**SELMON
EXPRESSWAY**

Whiting Street PD&E Study

Pond Siting Report

March 2022

| Figure 2.3: Existing Land Use Map | 9 |

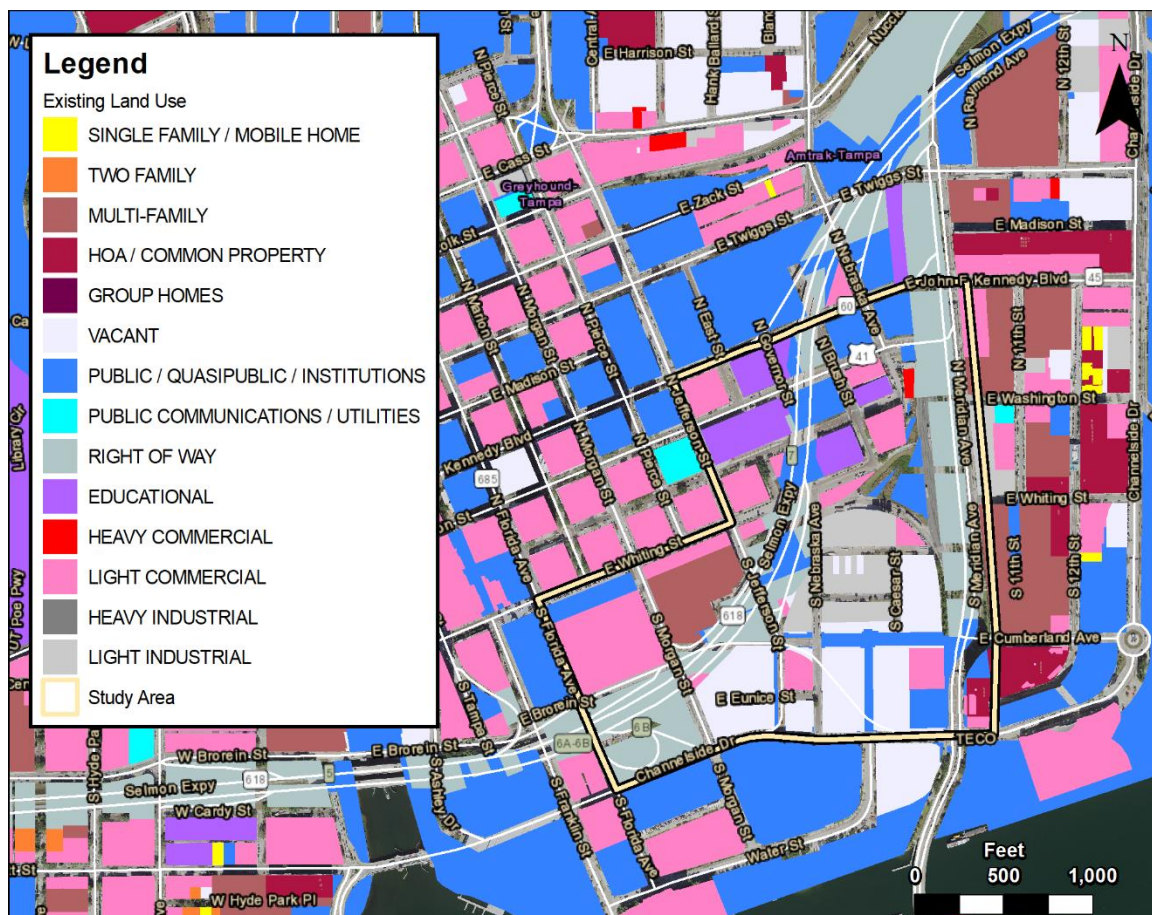
4. PDF Page 15 of 69, Figure 2.3 Project Area Location: Is it possible to get a clearer image for this figure? The text in the legend is blurry. Also, please verify Figure label. Should it read, “Figure 2.3 Existing Land Use Map” since earlier Figure 1.2 on PDF Page 9 of 69 is titled “Project Area Location Map”?
[Response: Agree. Figure 2.3 has been revised and the figure label has been corrected.](#)
Follow-up Comment: Response accepted.

WHITING STREET PD&E STUDY EXISTING DRAINAGE MAP

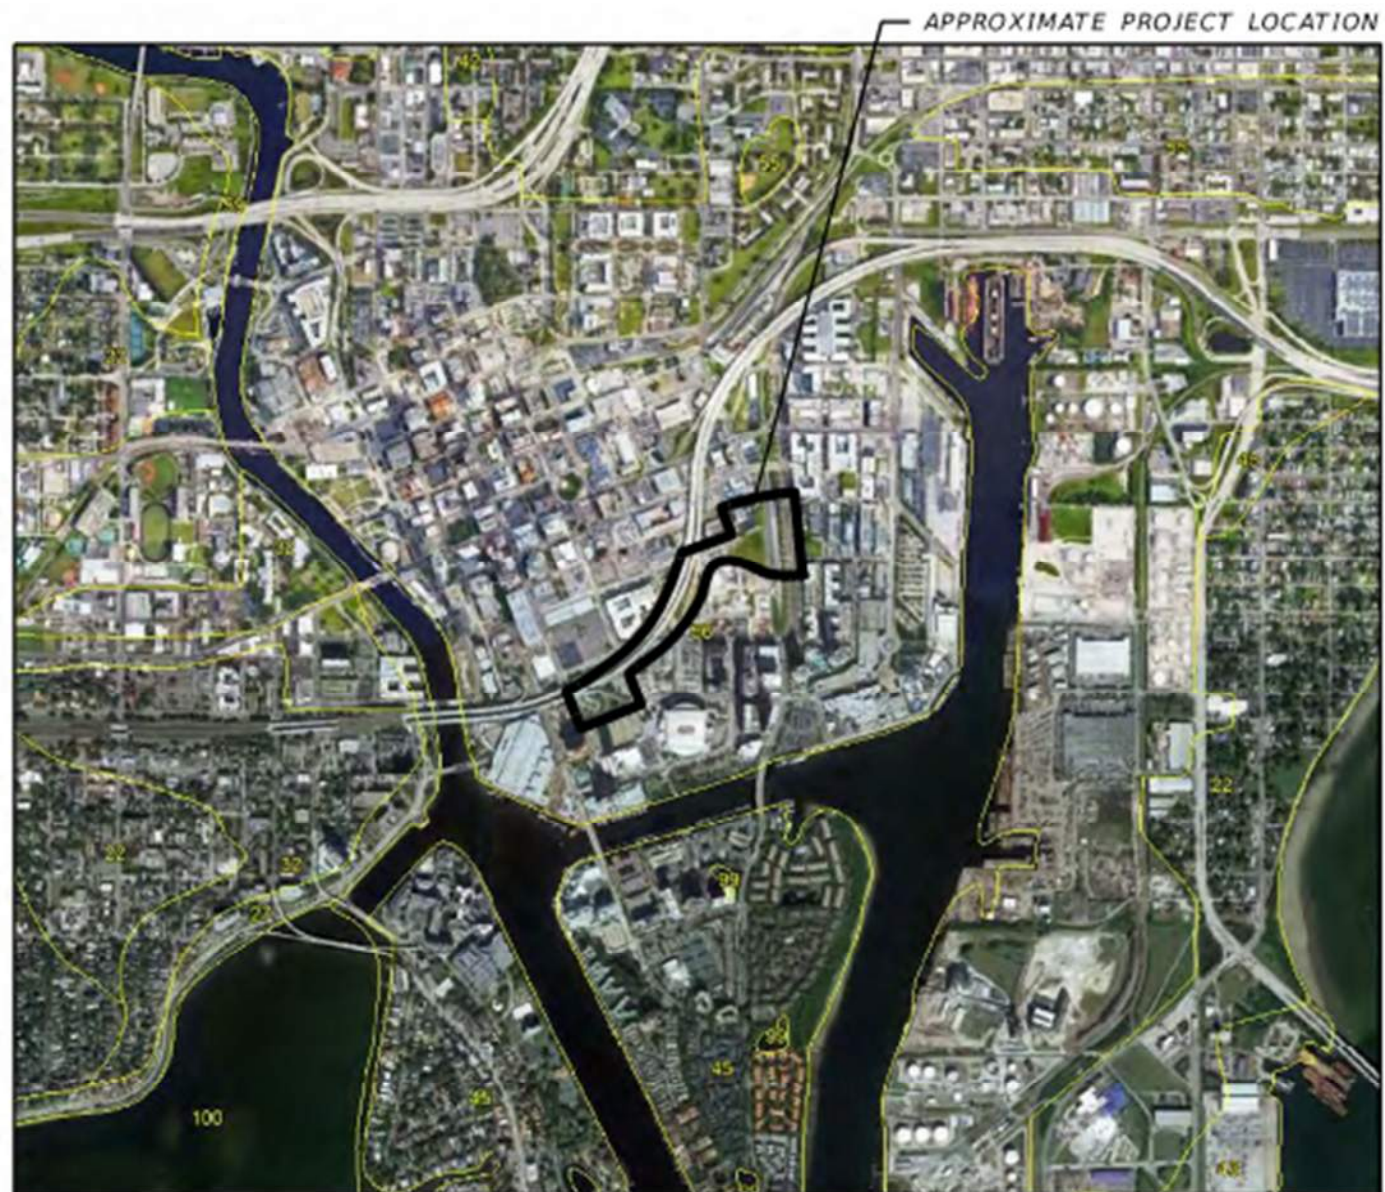
16. PDF Page 37 of 69: The brownish lines blend into the Aerial and should be changed to a different color. What do these lines depict? It appears that flow arrows are there (green) but that the scale provided the flow arrows cannot be read. Please provide larger flow arrows or, as an alternative, include flow arrows on the Pond exhibits later in the document.

Response: The drainage map will be revised for clarity. Flow arrows will be enlarged.

Figure F-1: Typical Pond Cross Section for Sizing Pond

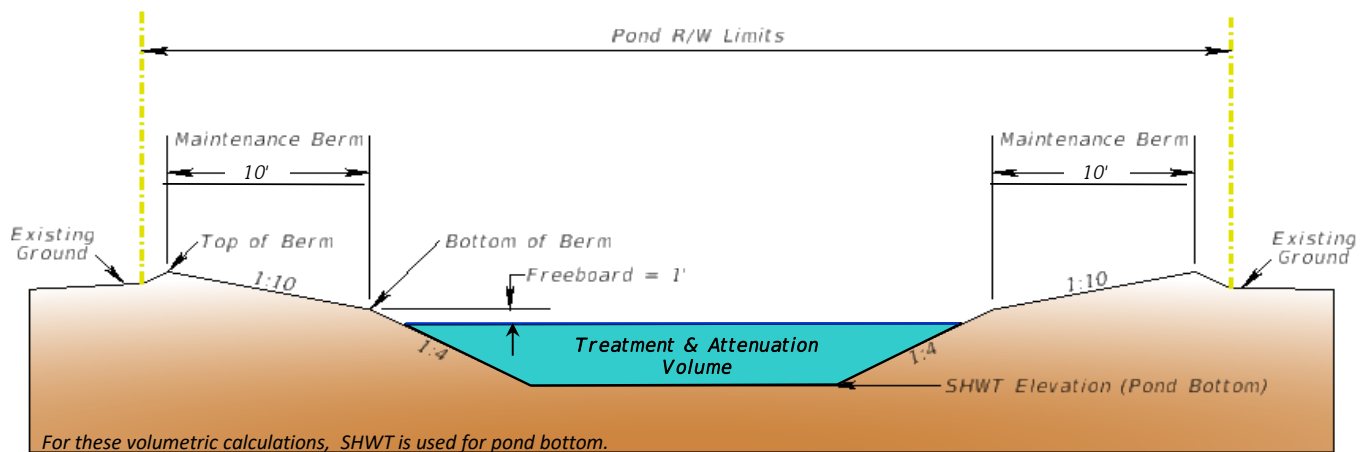
18. Sheet 60 of 69: Appendix F, Sheet F-2 please title and label the figure since it does not depict the actual pond.

Response: Agree. The figure will be titled and labeled.

BASIN 200

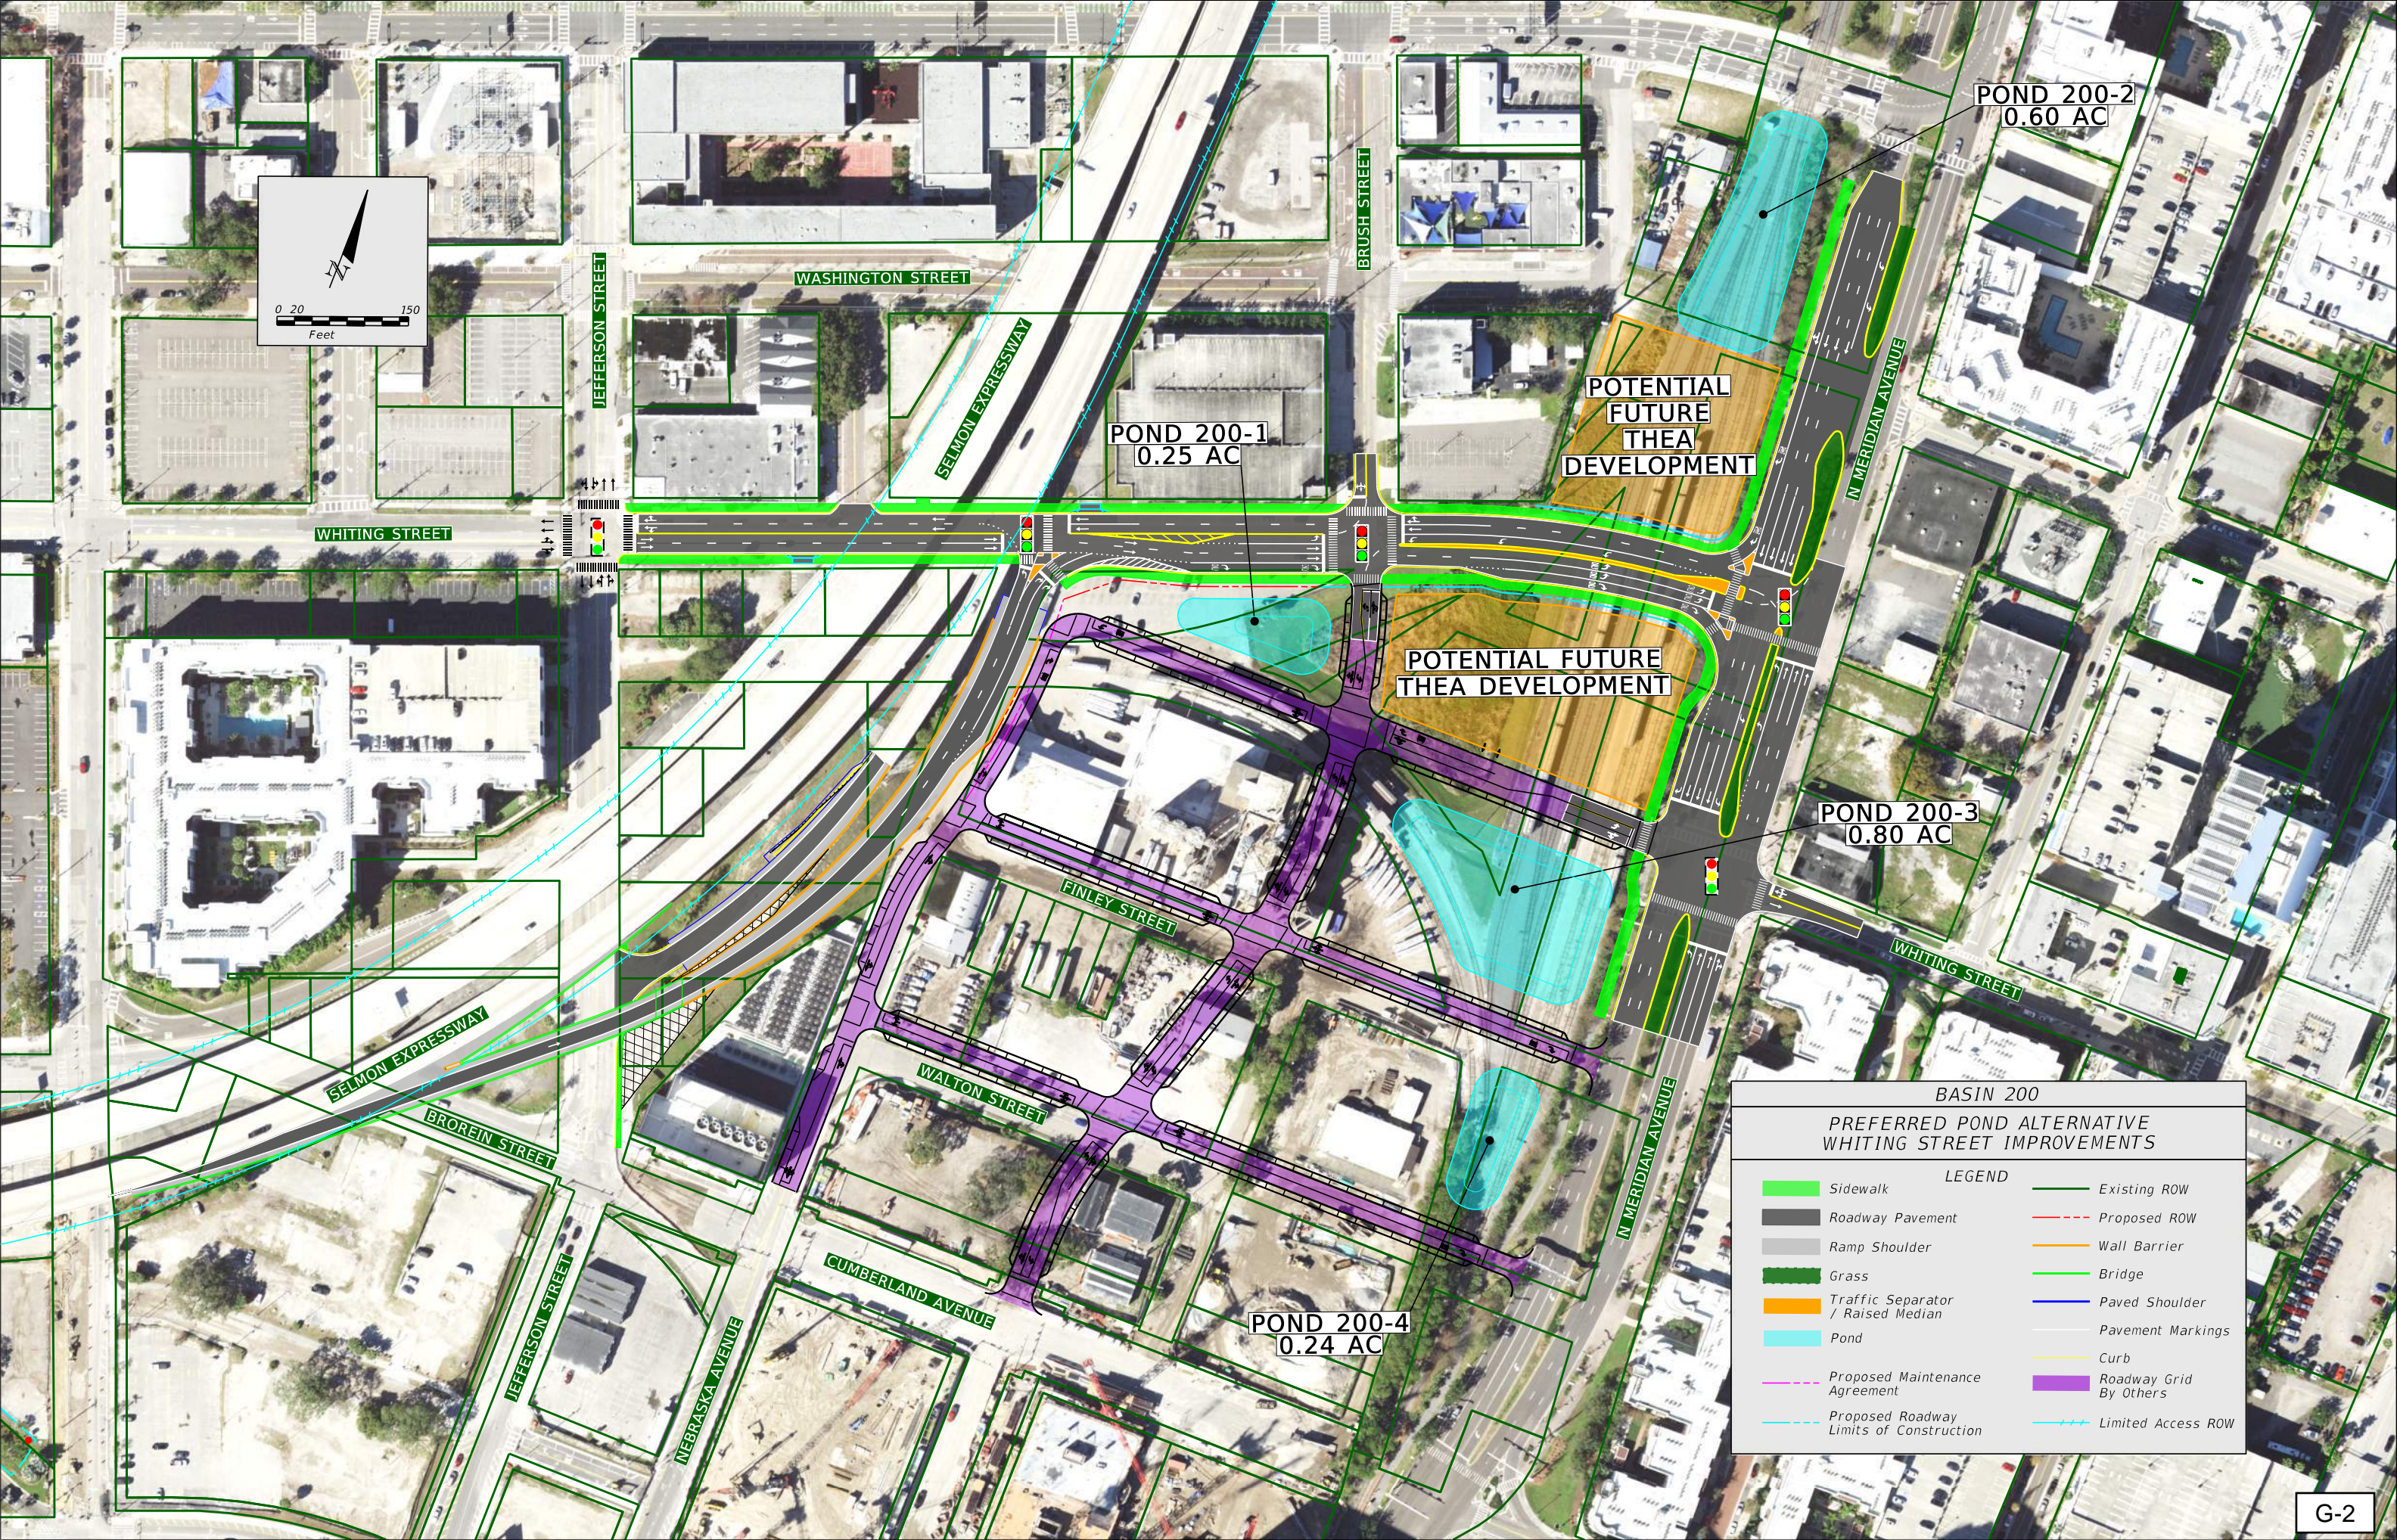
20. PDF Page 68 and 69: Earlier exhibits show possible contaminated soils in the areas of Pond 100, 200-1 and 200-3. Please provide preliminary information on contaminate mitigation per FDOT Drainage Manual (2021) Section 5.5.

21. PDF Page 68 and 69: Please remove the county parcel line work and replace with THEA ROW, existing pipe infrastructure and flow arrows if possible.

Response: Section 5.5 of the FDOT Drainage Manual (January 2022) requires preliminary information on potential hazardous waste contaminations (Section 5.5.1). Contamination mitigation is specific to the type and degree of contamination and is beyond the scope of the PD&E pond siting report. However, a commitment is contained within the PEIR that addresses additional screening of Medium and High risk ranked contamination sites. This commitment states, “For those locations with a risk ranking of MEDIUM and HIGH, Level II field screening should be considered during future project implementation phases and prior to construction. Note that additional information may become available or site-specific conditions may change from the time the Contamination Screening Evaluation Report (CSER) was prepared and should be considered prior to proceeding with roadway construction.”

Response: Review of existing as-built plans found that right-of-way for the Selmon Expressway varies between 150-200 feet but is generally 150 feet wide. Therefore, we will add LA ROW, centered between the eastbound and westbound directions, 150 feet wide. We recommend leaving the existing parcel lines because we are proposing right of way impacts to a few properties due to surface street improvements. Existing pipe infrastructure and flow arrows will be revised on the drainage map per response to Comment 16.
